<b>ADDENDUM NO. :</b>	<b>Four (4)</b>
<b>BID DUE TIME AND DATE:</b>	2:00 p.m., April 30, 2019 <b>(No Change)</b>
<b>BIDDER QUESTIONS BY:</b>	11:59 a.m., April 23, 2019
<b>LAST ADDENDUM ISSUED:</b>	11:59 p.m., April 25, 2019

**THE PURPOSE FOR THIS ADDENDUM IS:**

- **To provide a response to questions raised by Plan Holders;**
- **To modify/clarify specifications and drawings.**

**A306**

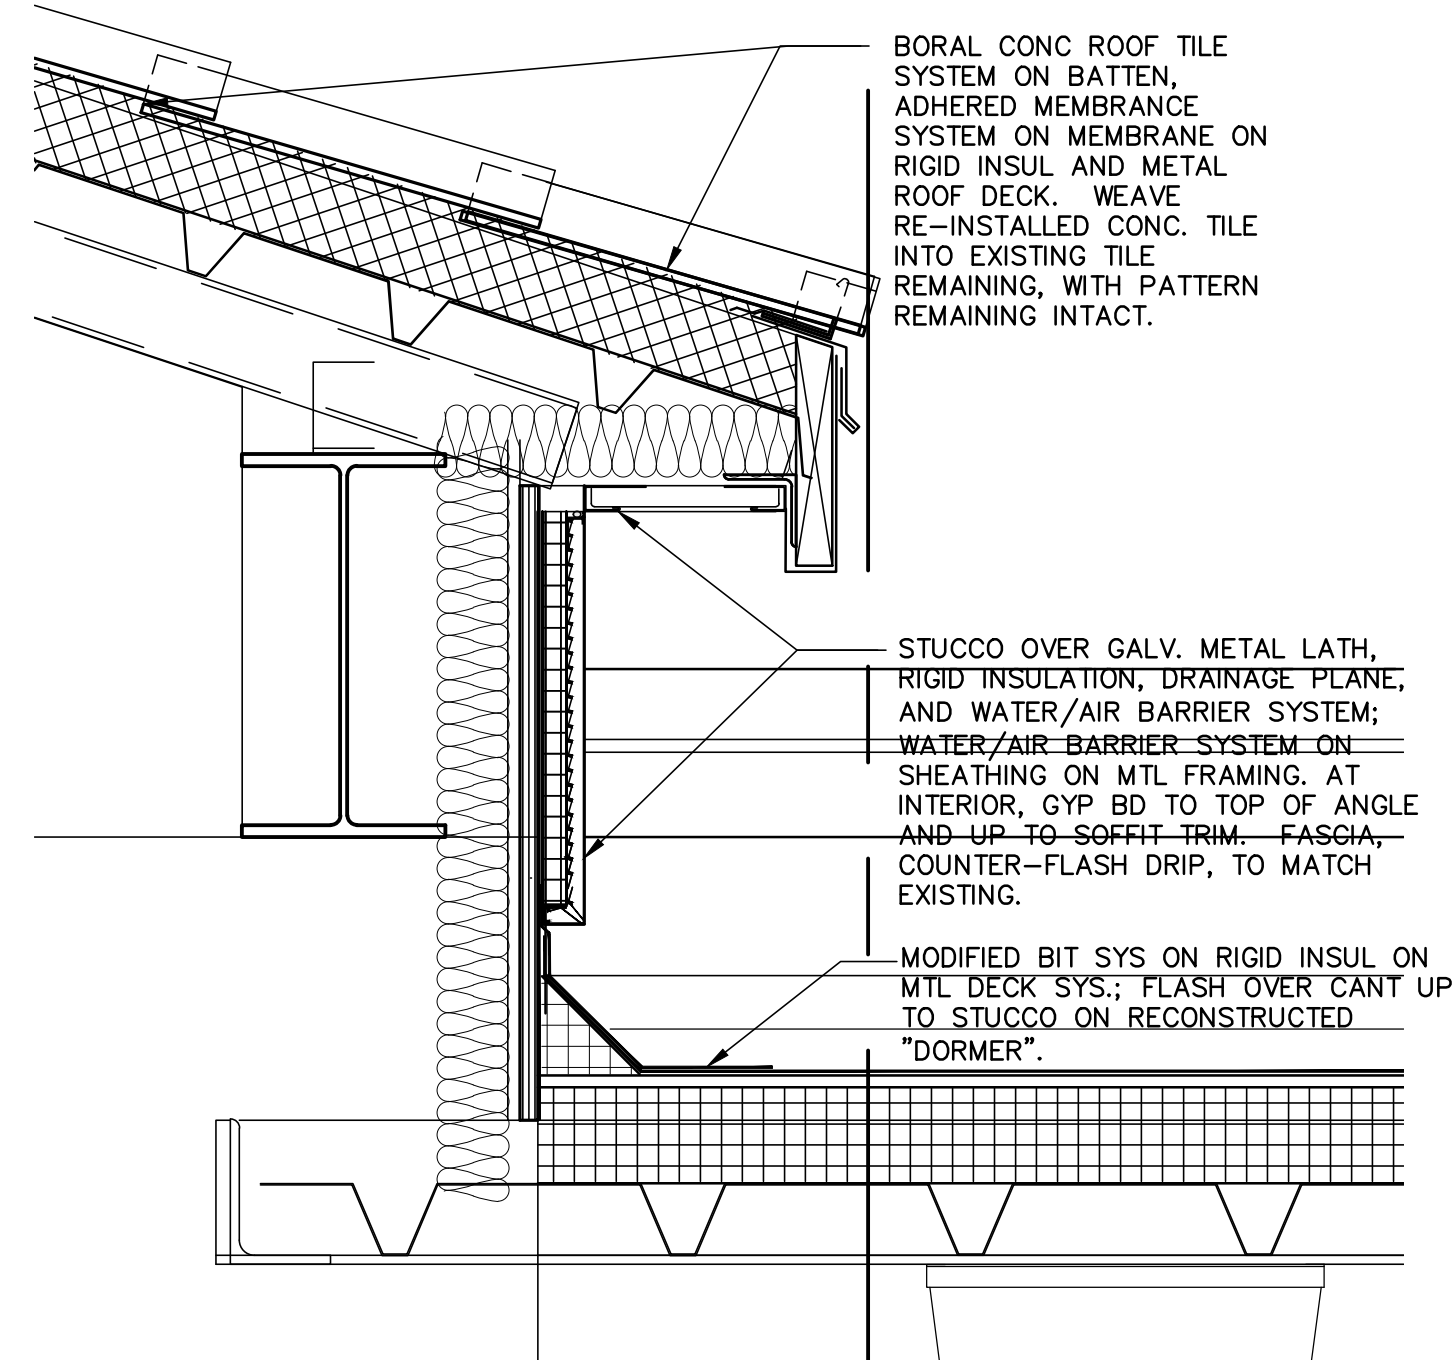
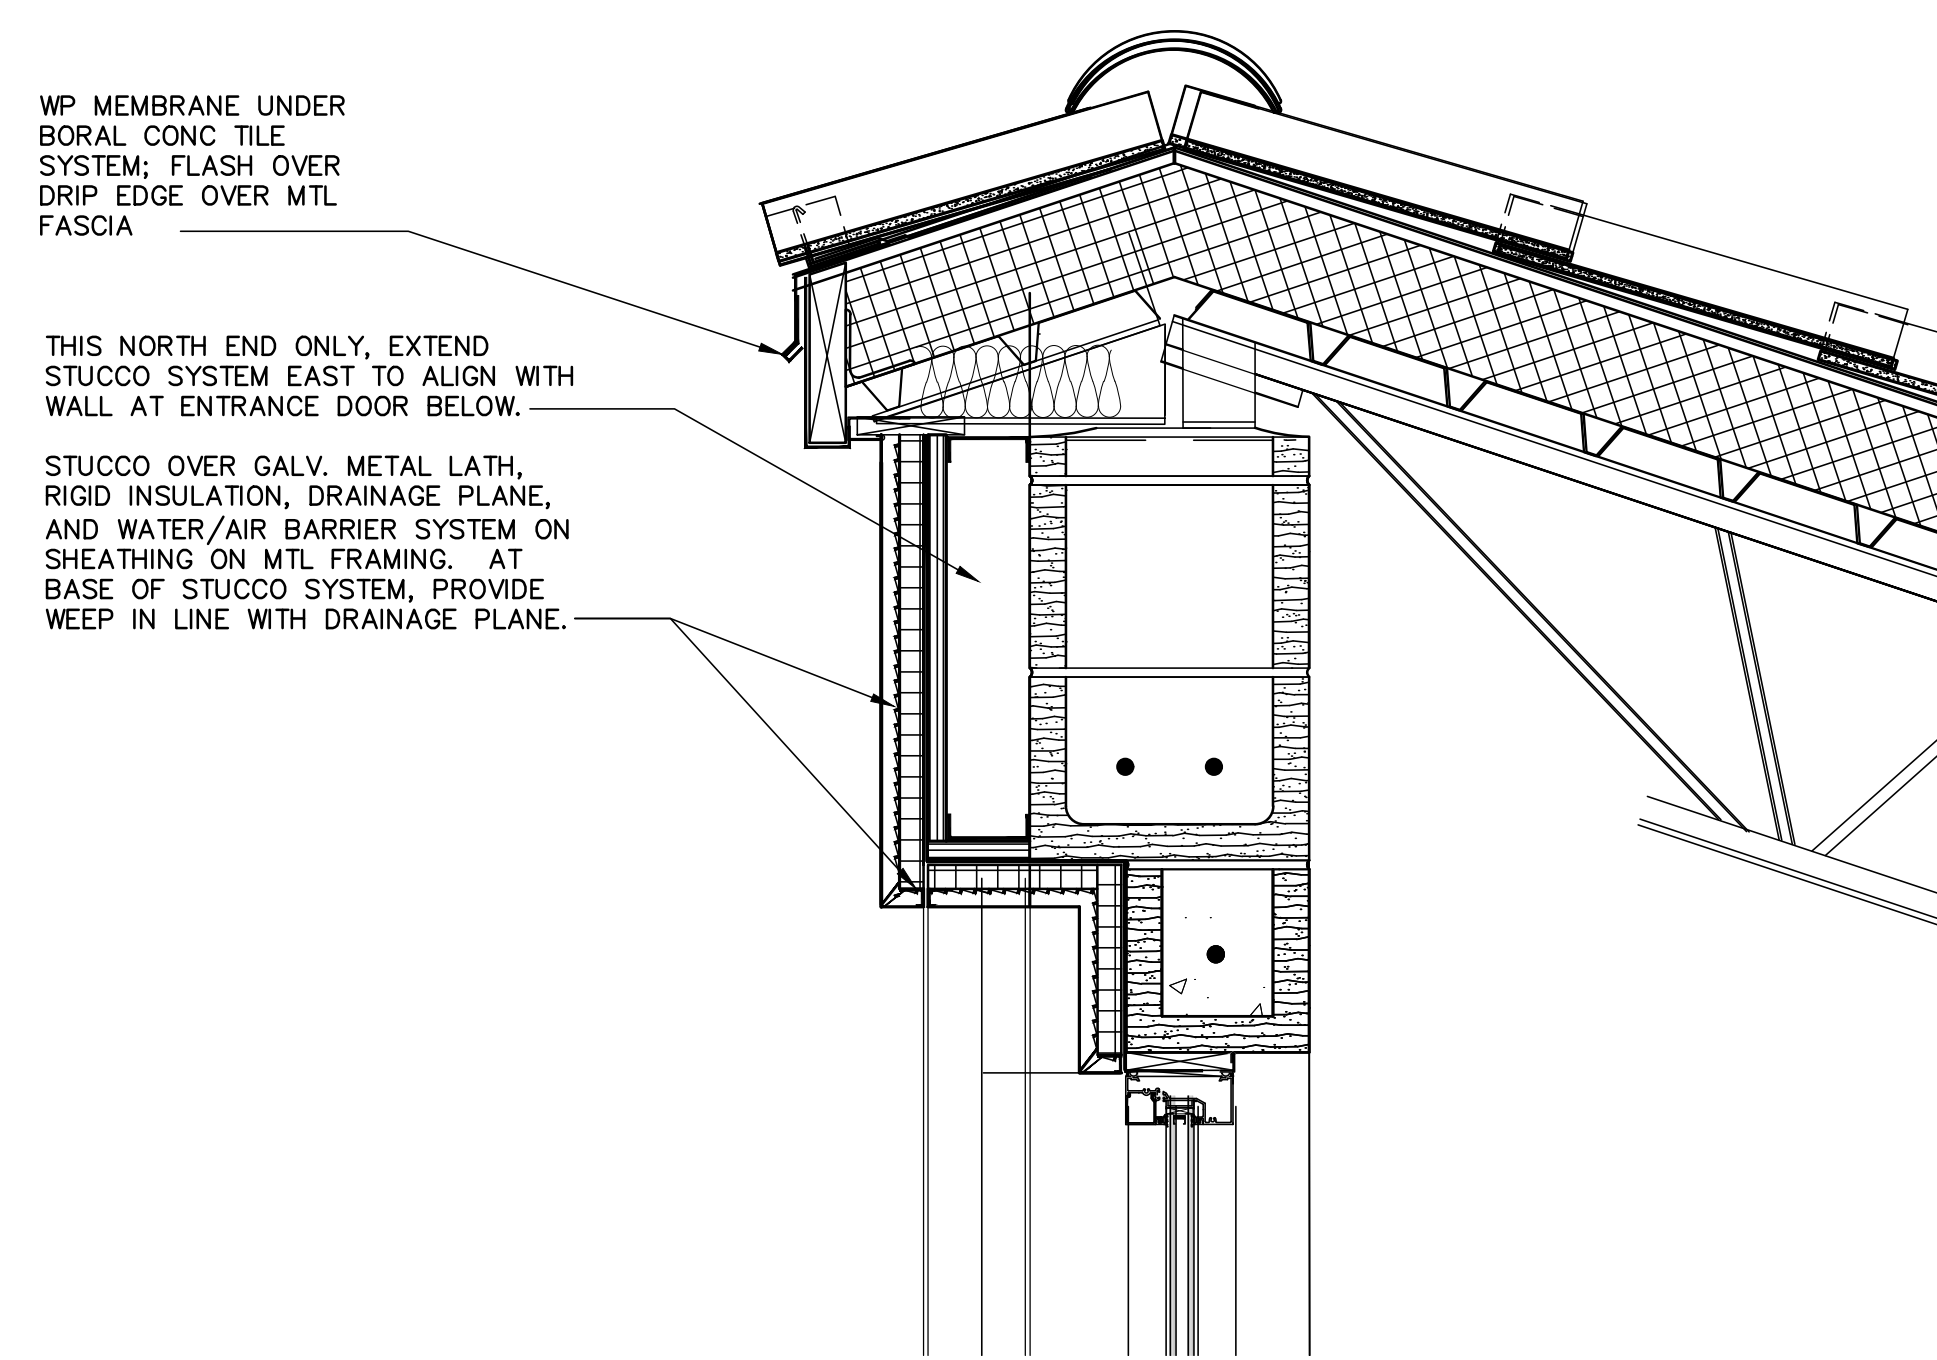
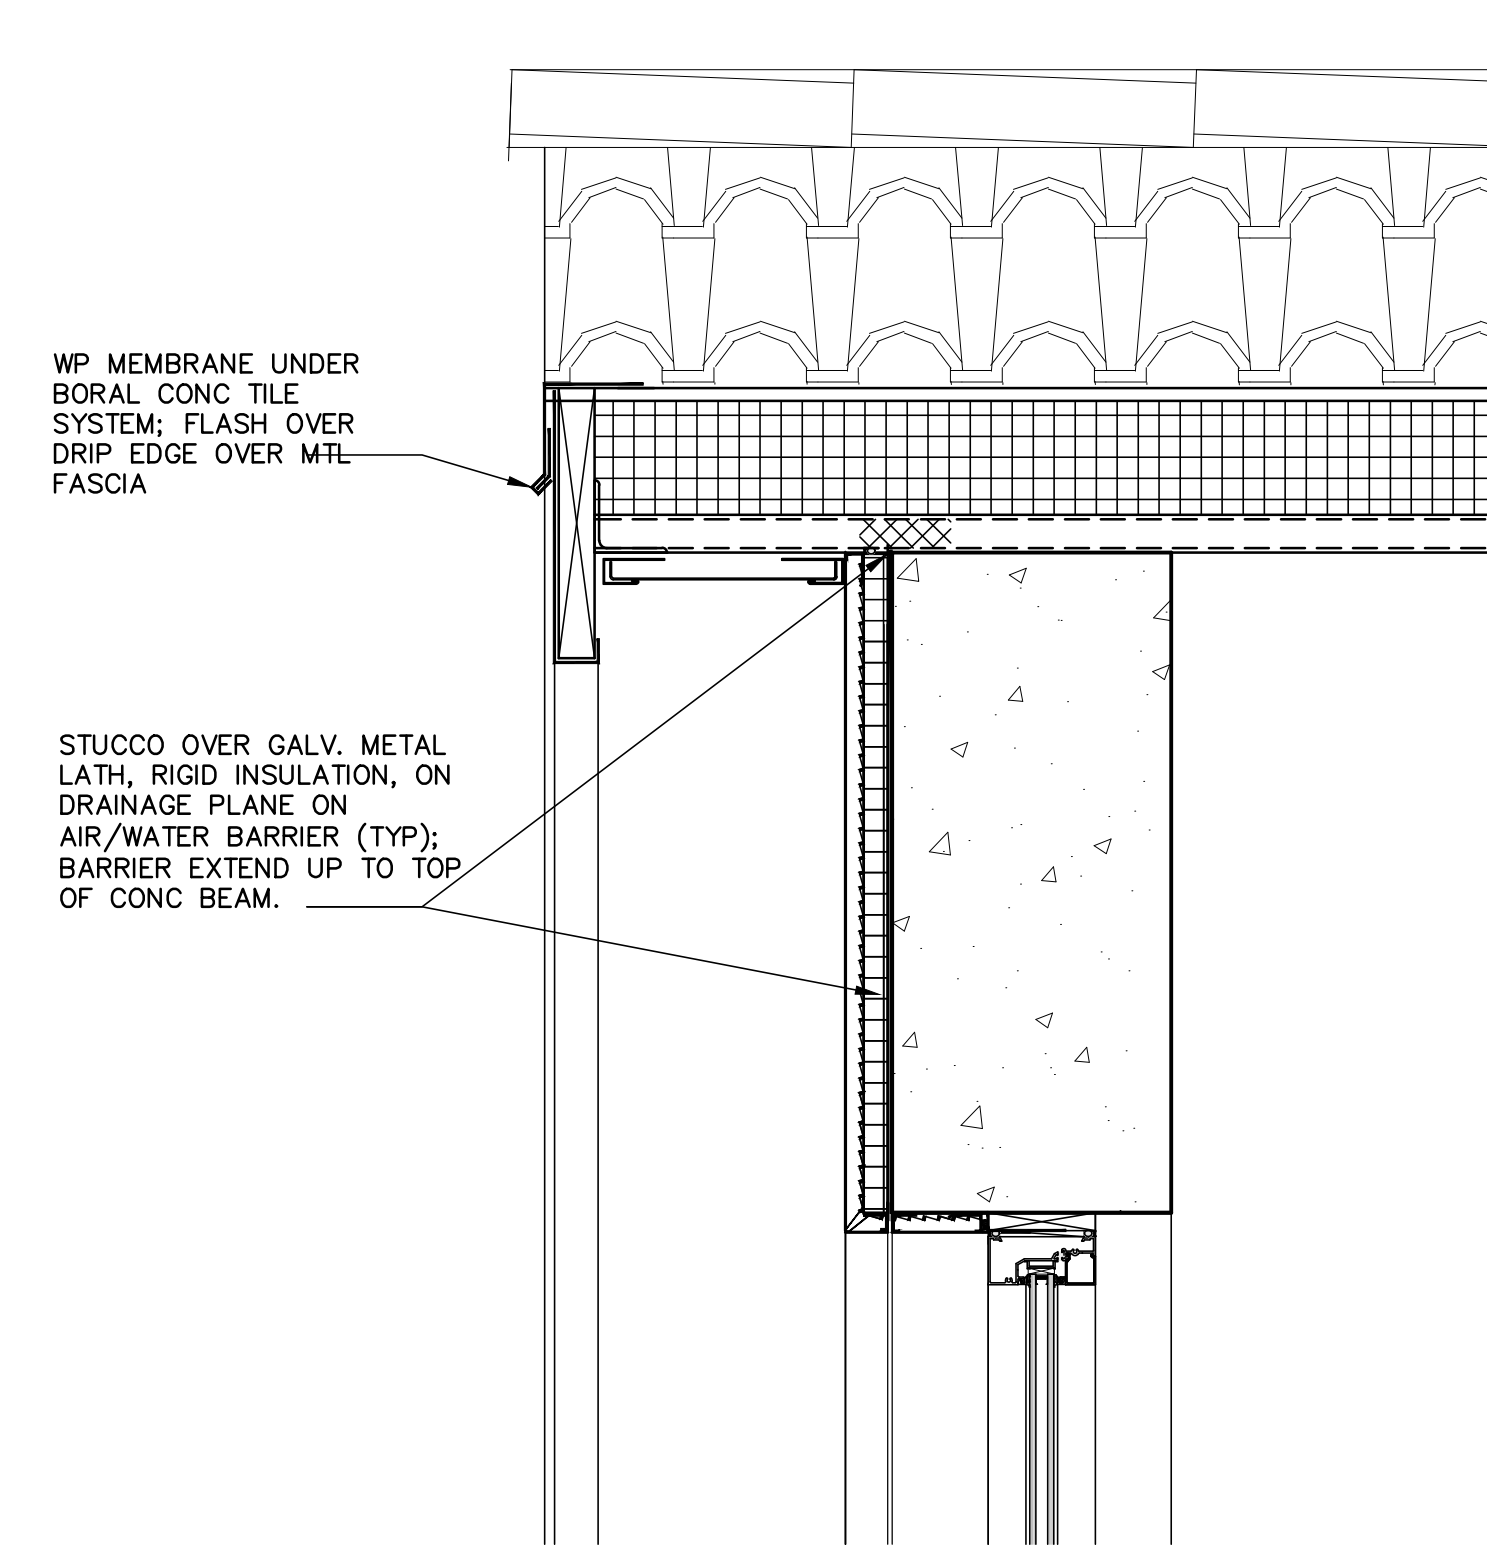
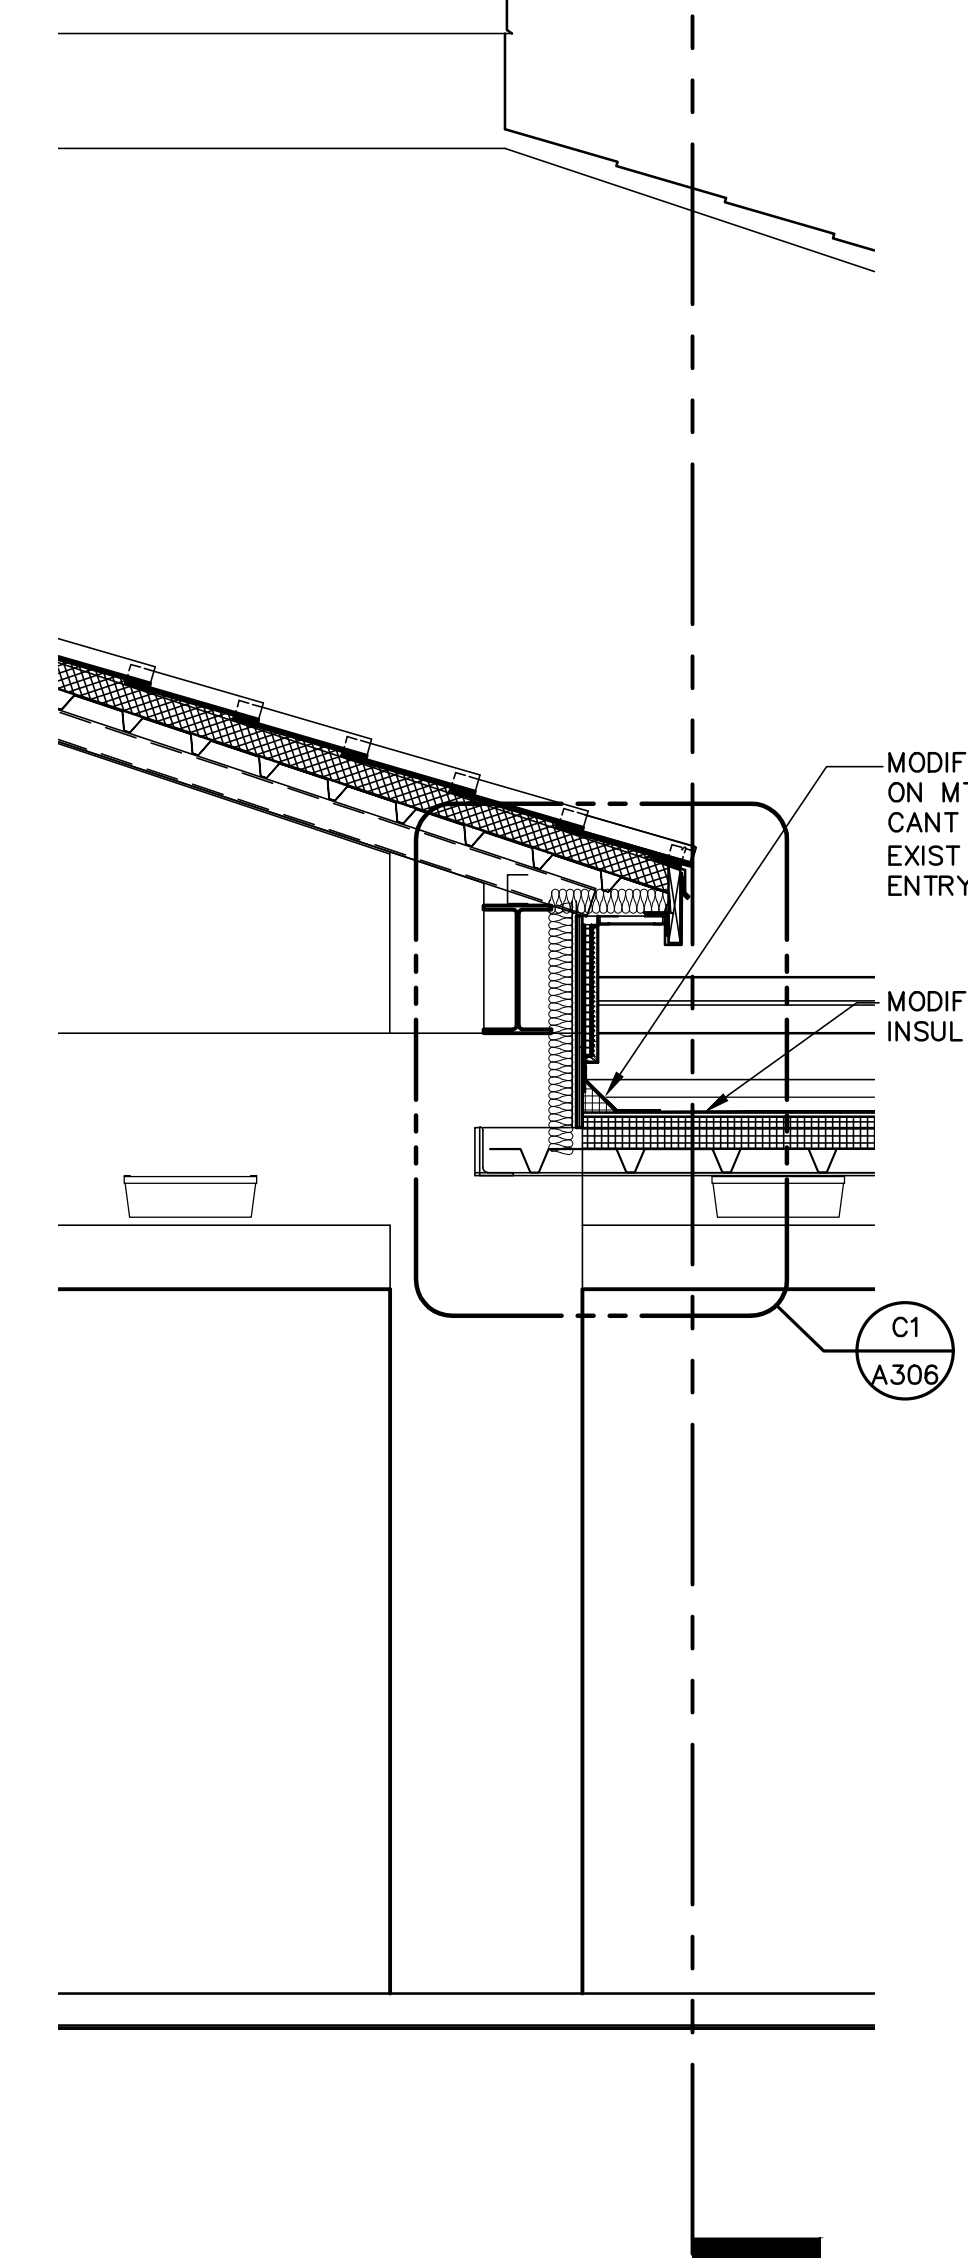
- Clarification on the wall types (section on acoustical separation, 2 hr, and detail at top of 10' wall) and ceiling cloud detail(s) and finish details such intent of columns for exposed electrical on CMU
- HVAC details such as air handler coil connection (what's needed re isolation valves, strainers, etc.)
- Extent of chilled water line treatment
- Specs/detail on OA louver to be installed within storefront (shown on HVAC, visible on Section A301, not A202 or A602)
- Redundancy on, and revisions to a few Hardware items; see hardware Spec sections attached.
- Sections clarified to indicate sill pan, as well as location of drainage barrier; all sections at stucco clarified to show weep at base of drainage plane. Additionally, simplify cast sills.

- A301 Building Sections
- A302 Building Sections
- A303 Ext Wall Sections & Details
- A304 Ext Wall Sections & Details
- A306 Ext Wall Sections & Details
- A502 Ceiling Details
- A601 Finish Schedule w/ Details
- P101, Updated plan to show missing fixtures and missing sanitary and vent piping
- P102, Updated plan to show missing fixtures, missing domestic water piping and missing gas piping
- P101, Updated plan to show missing fixtures and missing sanitary and vent piping
- P201, Updated plan to show missing fixtures and missing sanitary and vent piping
- P202, Updated plan to show missing fixtures, domestic water piping and missing gas piping
- M401, Added detail for chilled water connections to AHU
